**SUBJECT: CONDITIONAL USE / CLASS 3 SITE PLAN REVIEW / CLASS 2 AND
ADJUSTMENT / CLASS 2 DRIVEWAY APPROACH PERMIT / CLASS 1
DESIGN REVIEW CASE NO. CU-SPR-ADJ-DAP-DR20-02
2095 FAIRGROUNDS ROAD NE
AMANDA NO. 19-124717-ZO, 19-124718-RP, 19-125096-ZO, 19-
125097-ZO & 19-125098-DR**

Summary: A proposal to construct a coffee cafe with a drive-through lane.

9 Site plan
A1.1 Scale 1:20

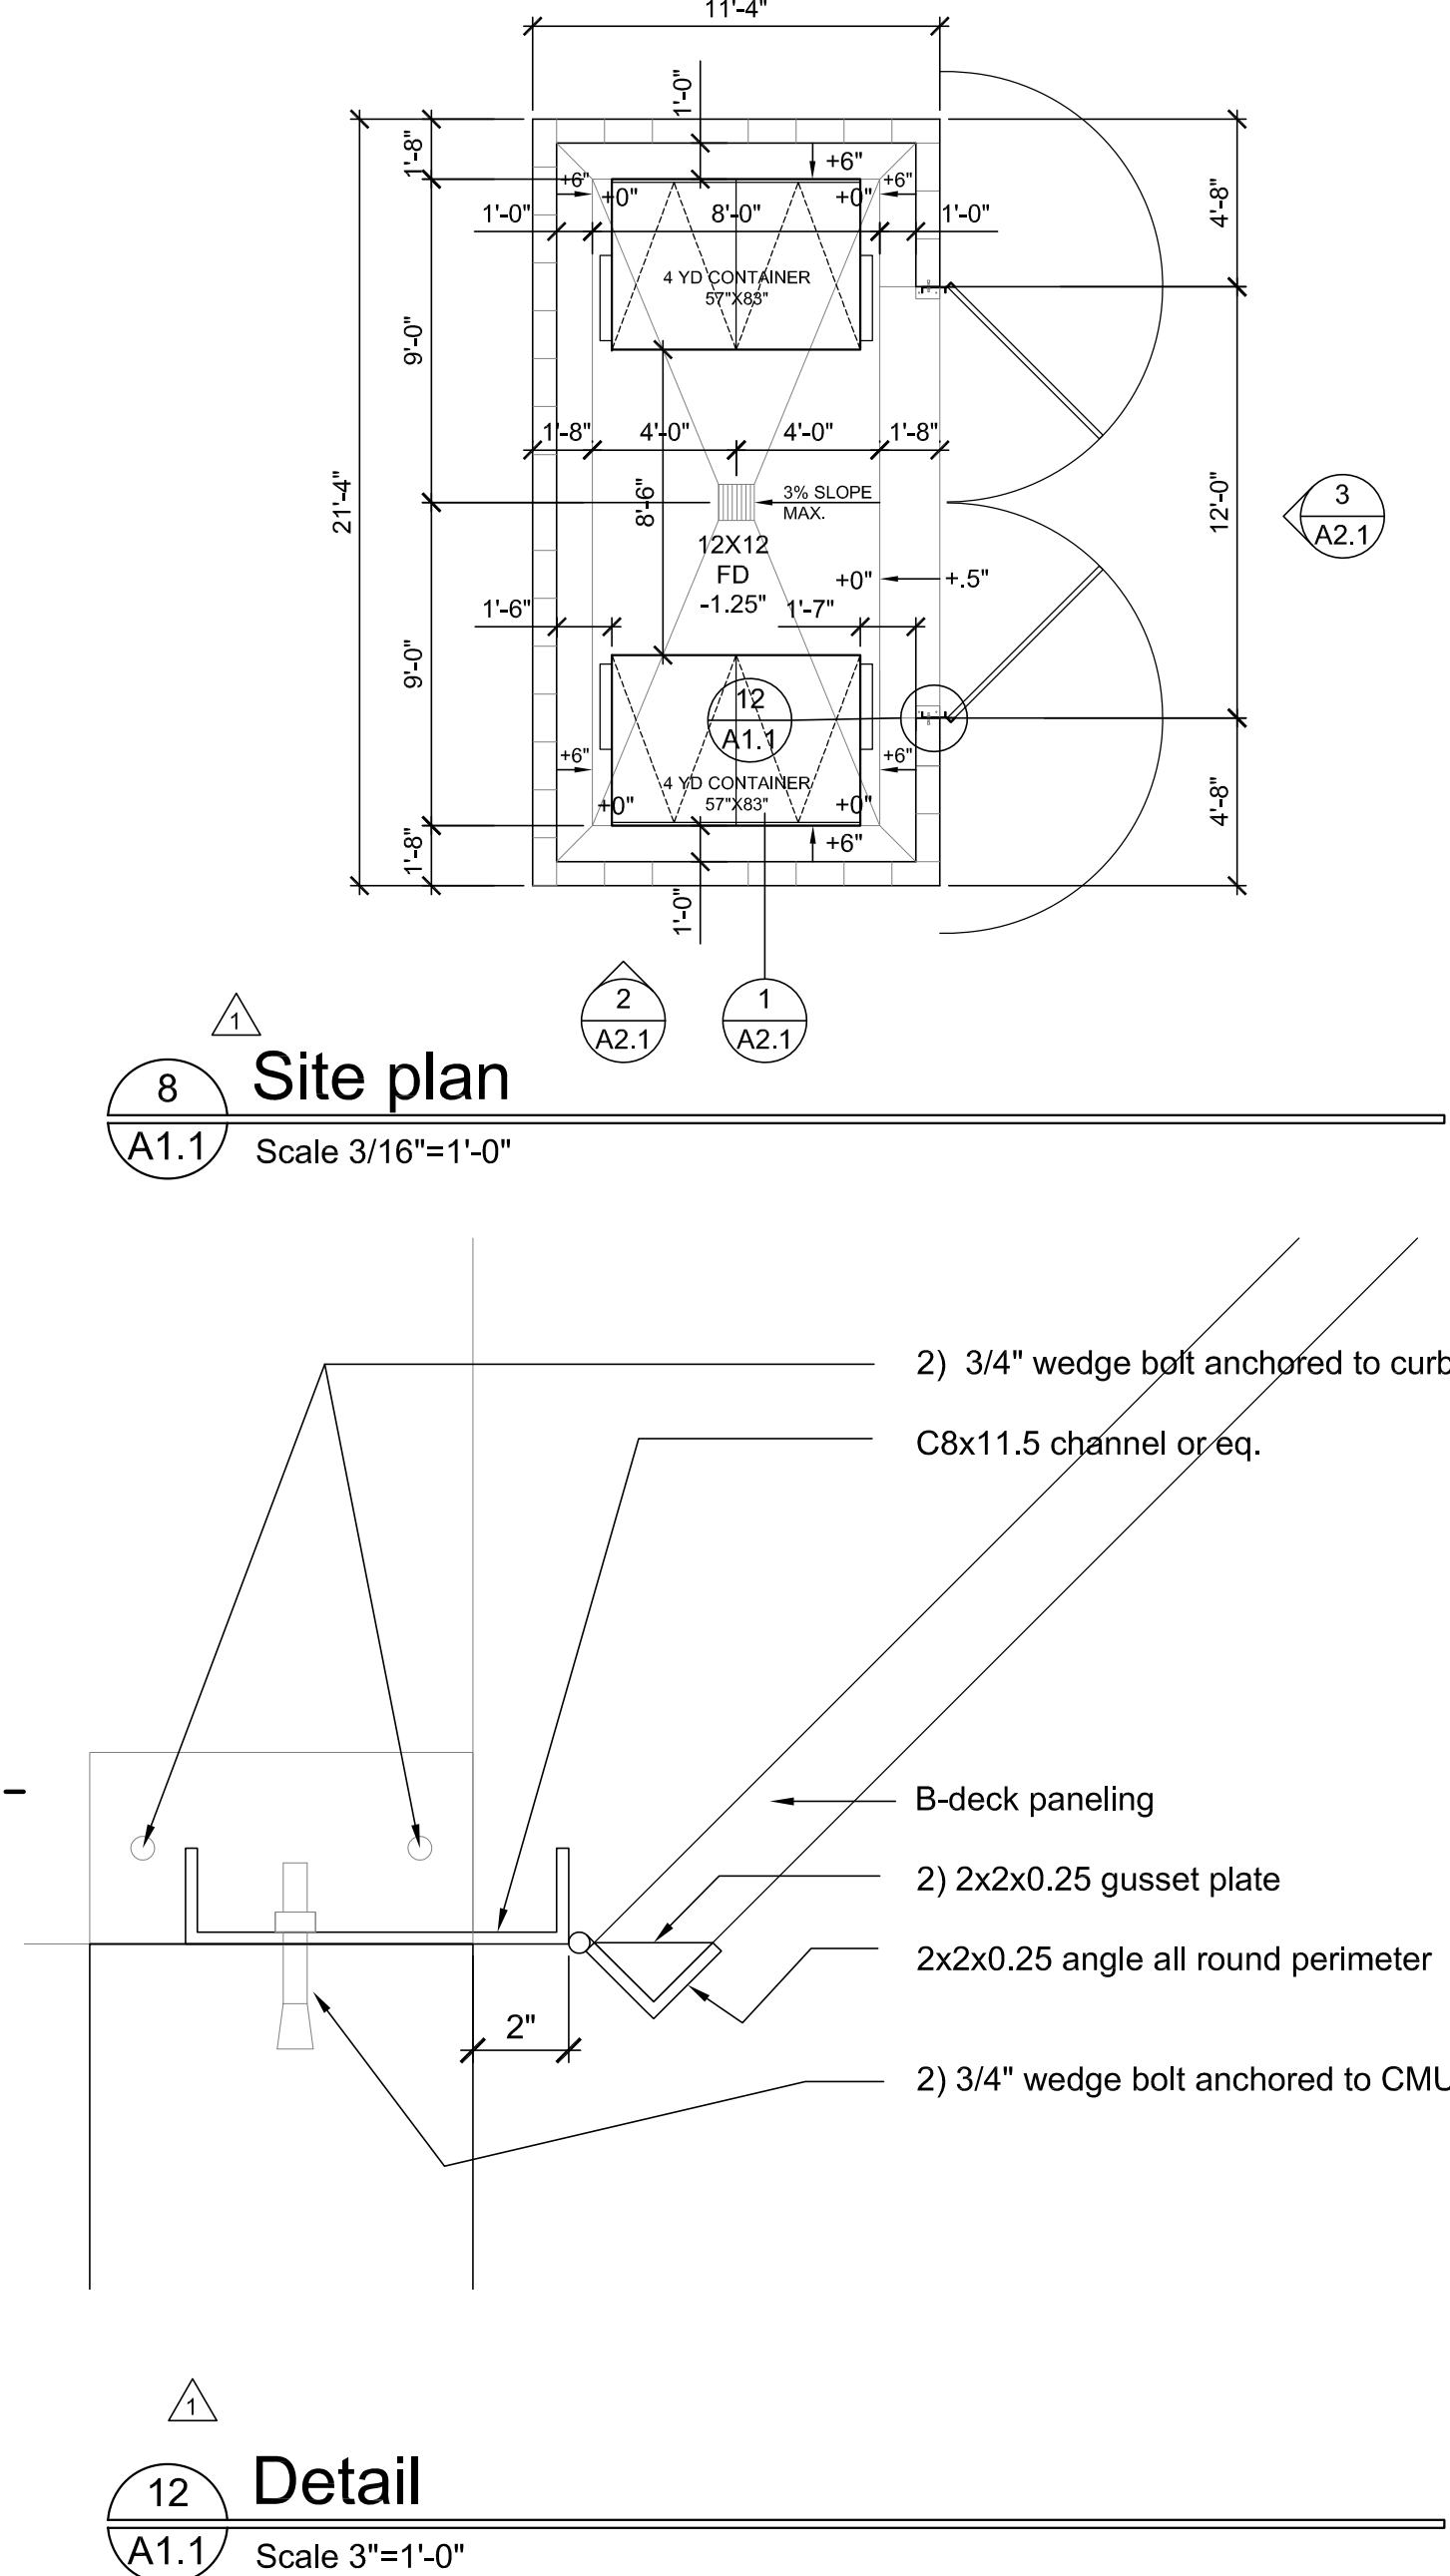
Finding: The proposed building is set back more than five feet from the property line. However, wing walls at the main entry proposed to provide a building offset to meet design standards are approximately 1'9" from the front property line. The applicant may meet the five-foot setback as well as the design standards in several ways: for example, by shifting the building, drive-through lane, and landscaped area farther away from the street and changing parking spaces 9 through 19 to compact spaces (13-foot stripes rather than 17-foot stripes) or by redesigning the building to recess the entryway by four feet rather than extend the entryway outward by four feet. Staff recommends the following condition to ensure that the proposal meets the setback in the CR zone.

Within the landscaped setbacks for the vehicle use areas abutting residential zones, Type C landscaping with one plant unit per 20 square feet and a minimum 6-foot-tall fence or wall is required. Required screening in the form of a fence, wall, or landscaping shall be sight-obscuring (at least 75 percent opaque when viewed from any angle at a point 25 feet away). Landscaping shall be of an evergreen species that will attain a height of at least 6 feet and 75 percent opacity within three years after planting. The site plan indicates an existing 6-foot-tall chain link fence along the property line abutting the residential zones. The fence must be opaque to meet the standard. Staff recommends the following

Finding: The proposed site plan shows pedestrian connections from the public sidewalk along Fairgrounds Road NE and Myrtle Avenue NE to the three building entrances. This standard is met.

Finding: The pedestrian connections shown on the applicant's plans are planned to striped and colored asphalt crossing the drive-through and parking lot and scored concrete at the plazas connecting to the public sidewalk. Additionally, all internal pedestrian connections are a minimum of five feet in width. As proposed, the development meets this criterion.

Finding: The site plan indicates that a new solid waste enclosure with receptacles greater than 1 cubic yard in size is proposed.

The proposed site plan indicates that 20 new off-street parking spaces will be provided. One of the proposed parking spaces will be ADA and the remainder are standard size parking spaces. No compact spaces are indicated on the site plan, but the conditions of approval above may require redesigning some spaces to compact spaces.

Condition 1: Provide a raised surface or speed bumps to delineate the pedestrian pathways that cross the drive-through lane.

Condition 4: Construct all walls of the building at least five feet from the property line abutting Fairgrounds Road NE and retain four-foot building offsets required to meet the design standards.

Condition 5: Provide a minimum 6-foot-tall sight-obscuring fence along the property line abutting the residential zones.

Condition 6: Provide a solid waste service area meeting all applicable standards of SRC 800.055.

Job No: 1933
Date: Nov. 11, 2019
File: Site Design Issue Set
DRAWN:
CHECKED: NYL
Sheet Title
Exterior Elevations

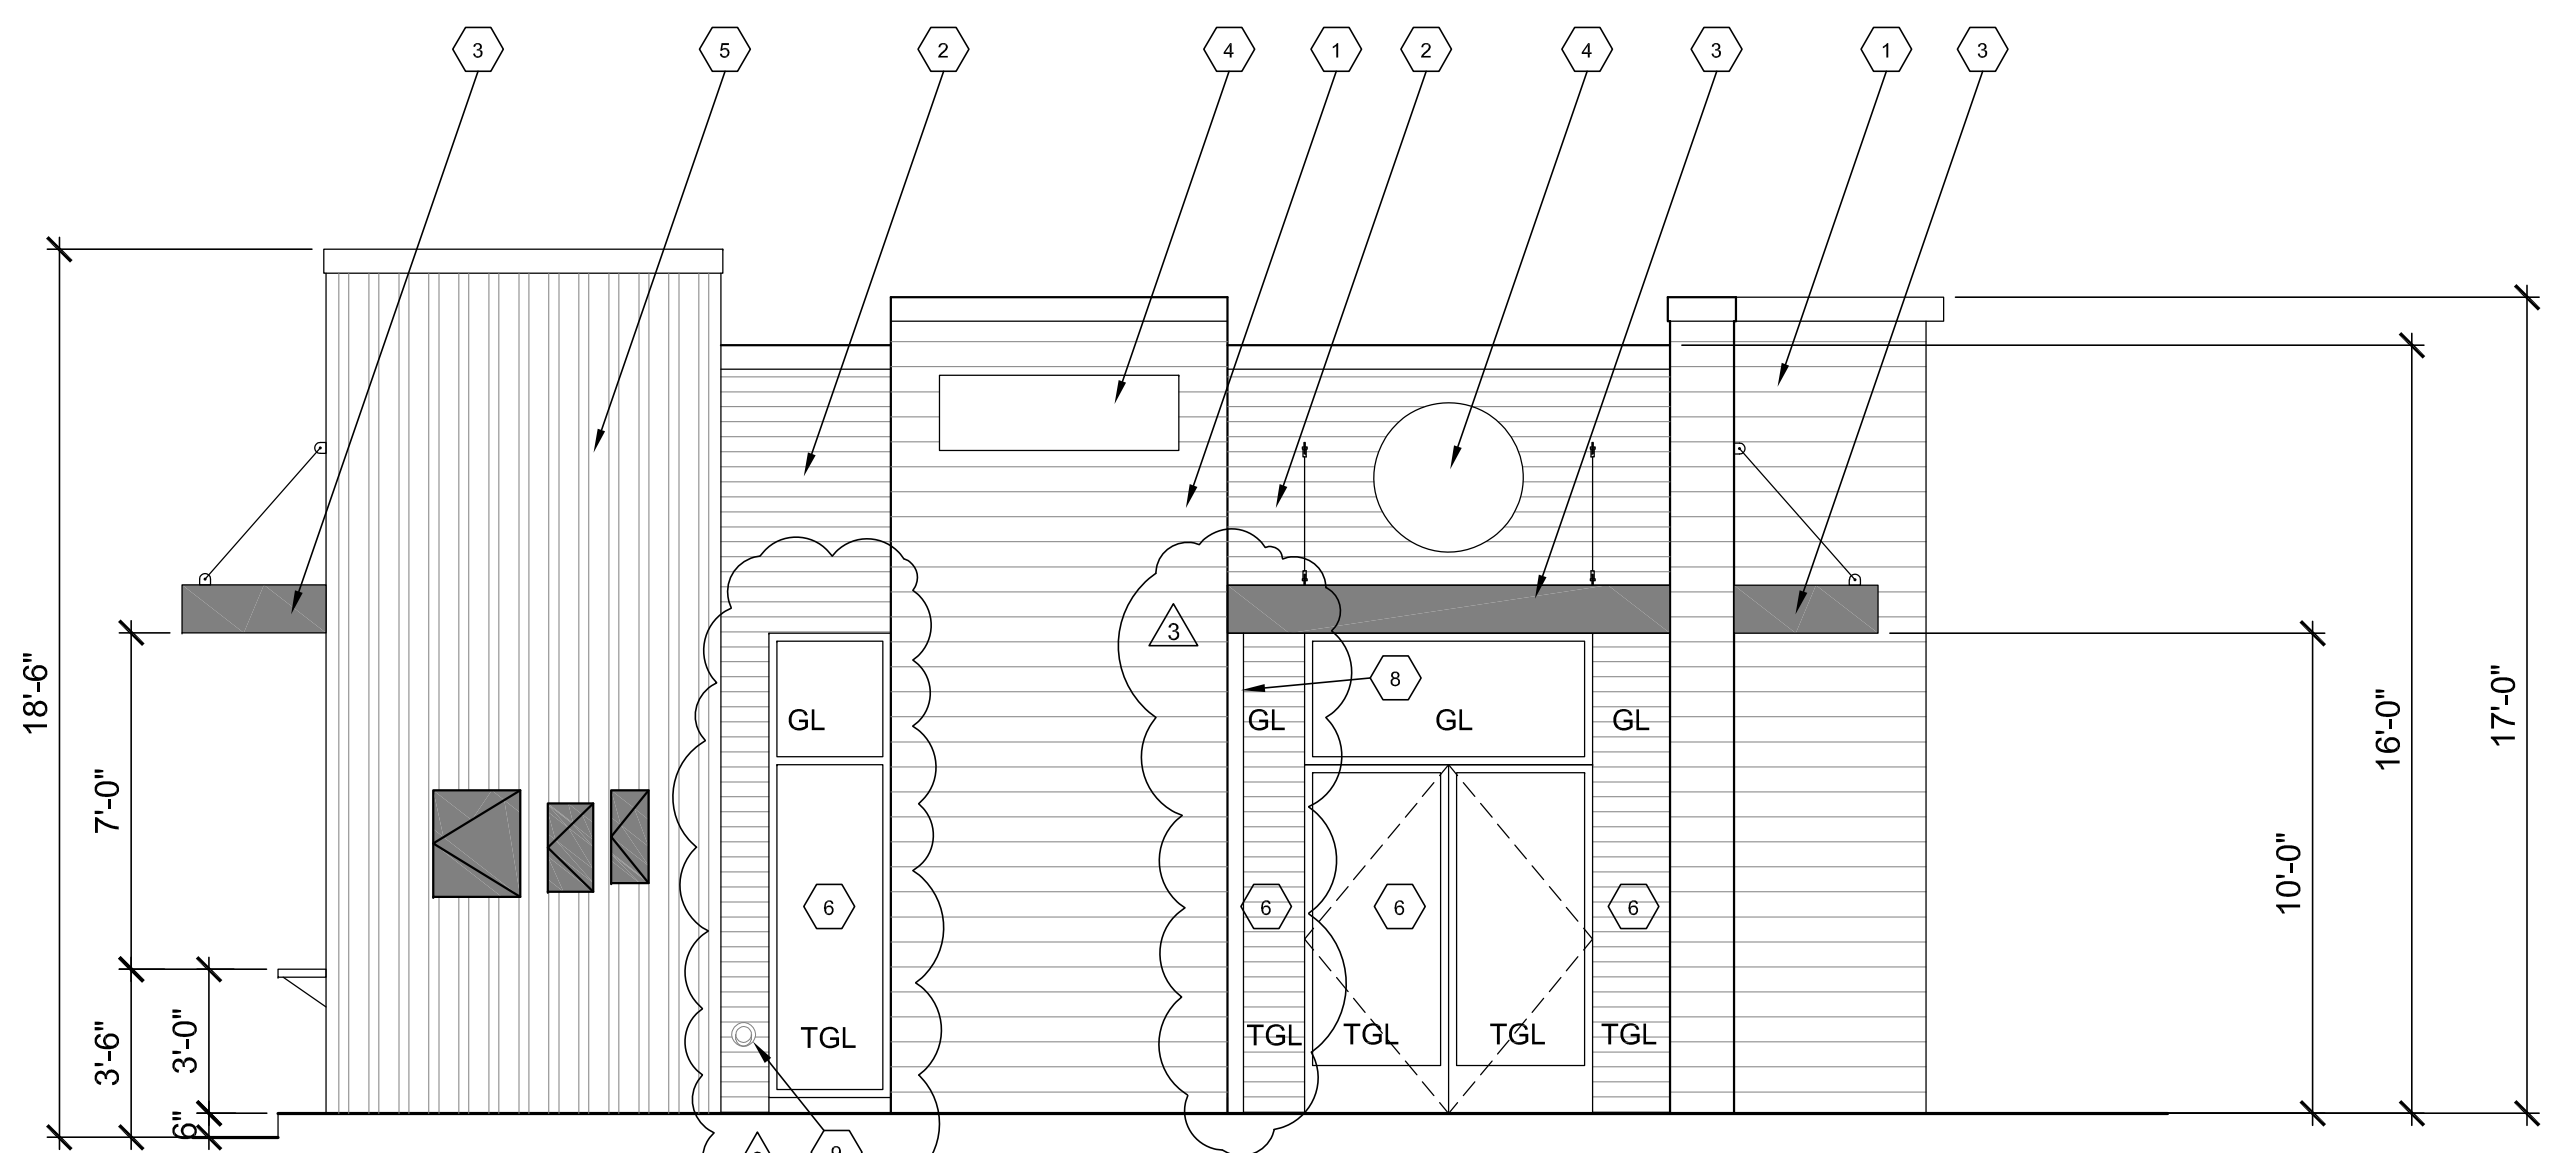
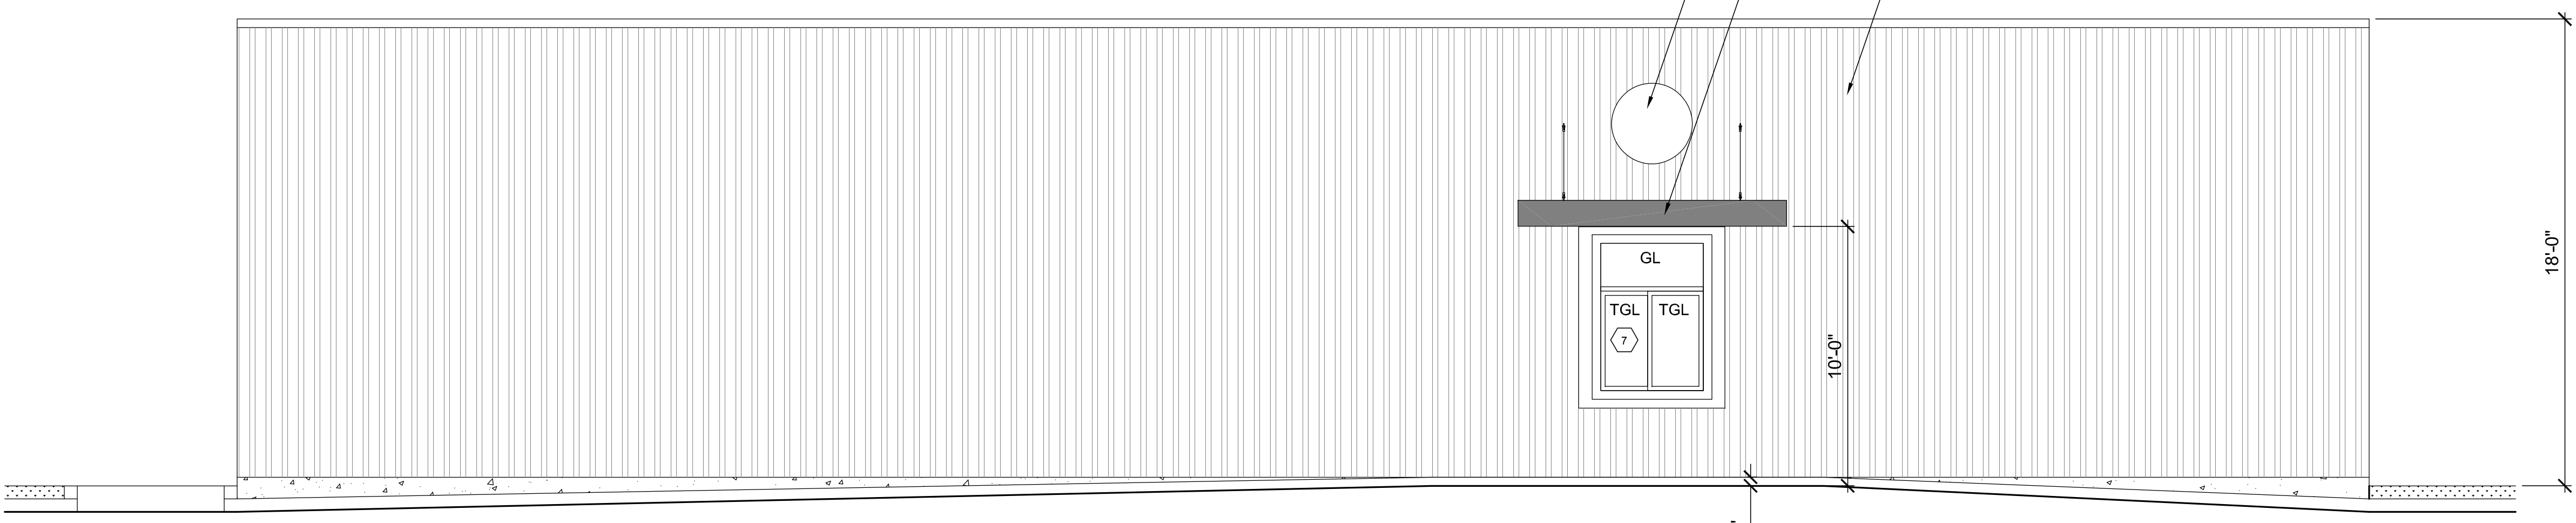
Finding: The site plan indicates that the façade facing Fairgrounds Road NE is 82 feet long, which requires a minimum of 53.3 linear feet of glazing ($82 \times .65 = 53.3$). The applicant's written statement and site plan indicate glazing along 55 linear feet, exceeding the minimum. The development meets this standard.

Finding: The plans submitted by the applicant show that the proposed building is 82 feet long, and offsets of at least four feet are provided at intervals of not more than 40 feet. The conditions above would require constructing all walls of the building at least five feet from the property line abutting Fairgrounds Road NE to meet the minimum setbacks of the CR zone and retaining four-foot building offsets to meet the design standards. As proposed and conditioned, the development meets this standard.
